Addendum No. 02

TO: PLANS AND SPECIFICATIONS FOR STATE OF MISSOURI

Elevator Replacement Governor's Mansion Jefferson City, MO Project No: O2036-01

BASEMENT FIRE ALARM PLAN

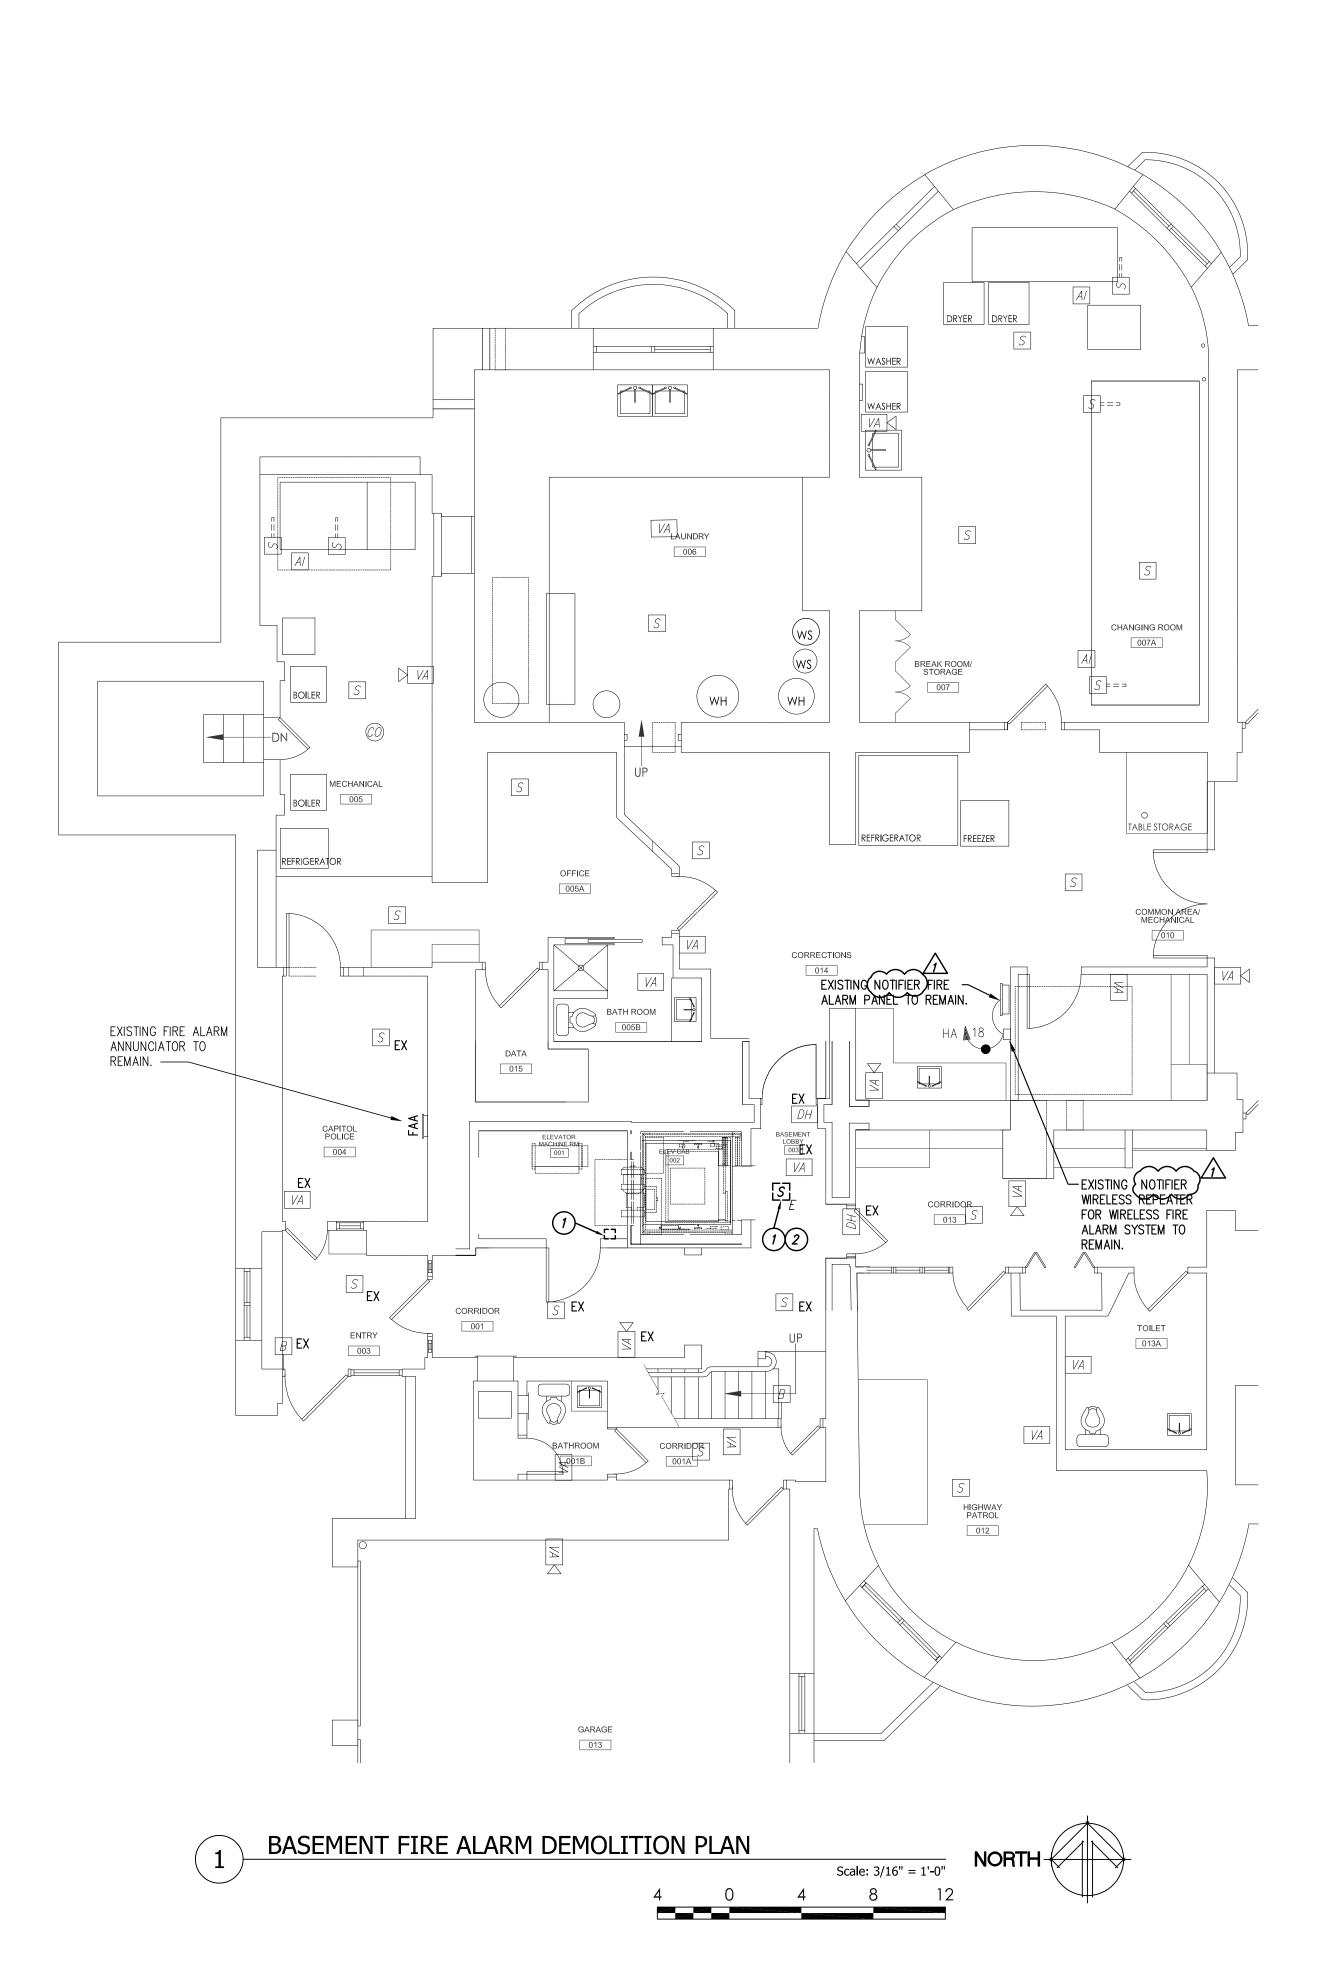
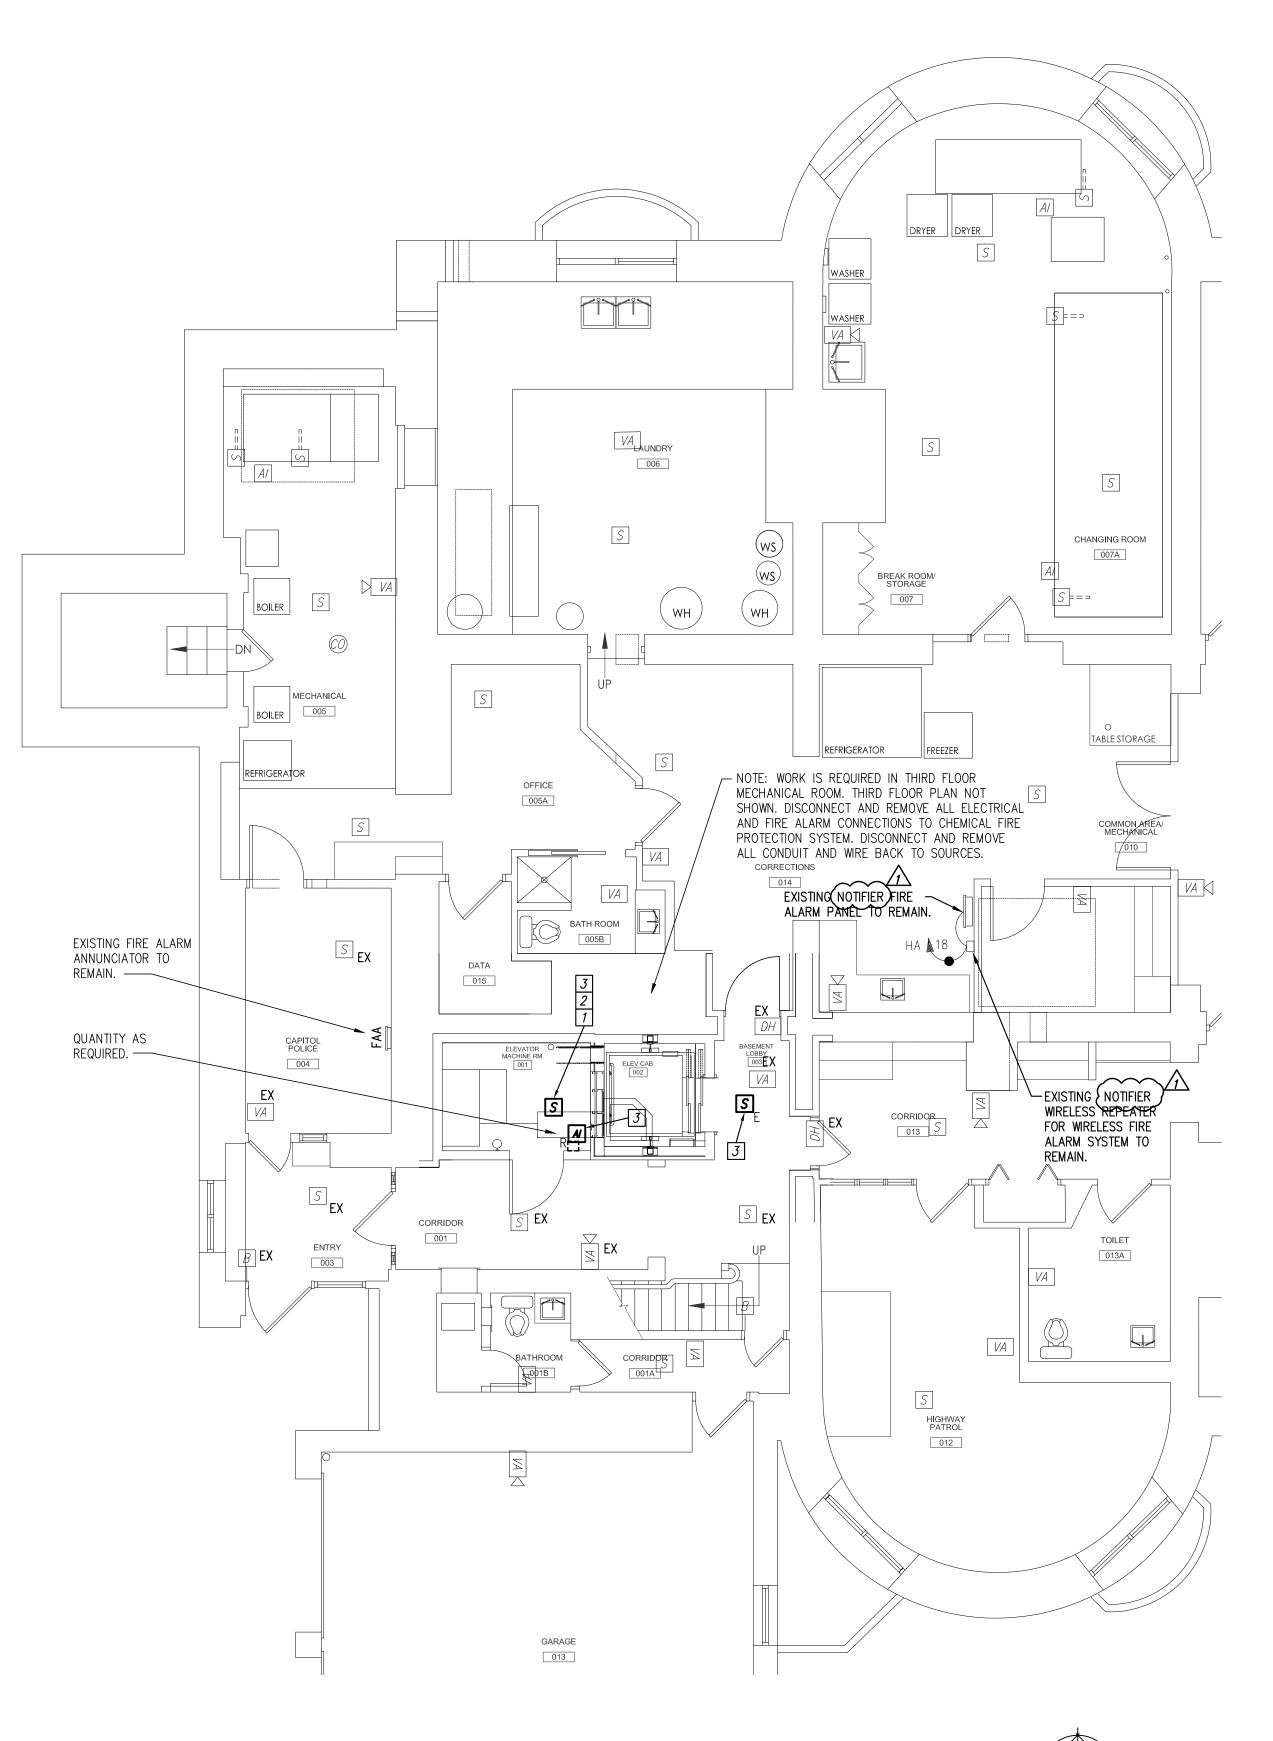
- 1. <u>Drawing EF100:</u>
 - a. REVISE detail 01 to show Notifier Panel as shown on revised sheet EF100.
 - b. REVISE detail 01 to show Notifier Repeater as shown on revised sheet EF100.
 - c. REVISE Keynote 01 as follows:

d. REVISE Keynote 02 as follows:

FURNISH AND INSTALL NEW NOTIFIER DEVICE IN LOCATION OF EXISTING JUNCTION BOX AND CONDUIT. MAKE ALL CONNECTIONS AS REQUIRED AT DEVICE LOCATION AND NOTIFIER PANEL LOCATED IN BASMENT.

FURNISH AND INSTALL NEW NOTIFIER SMOKE DETECTOR.
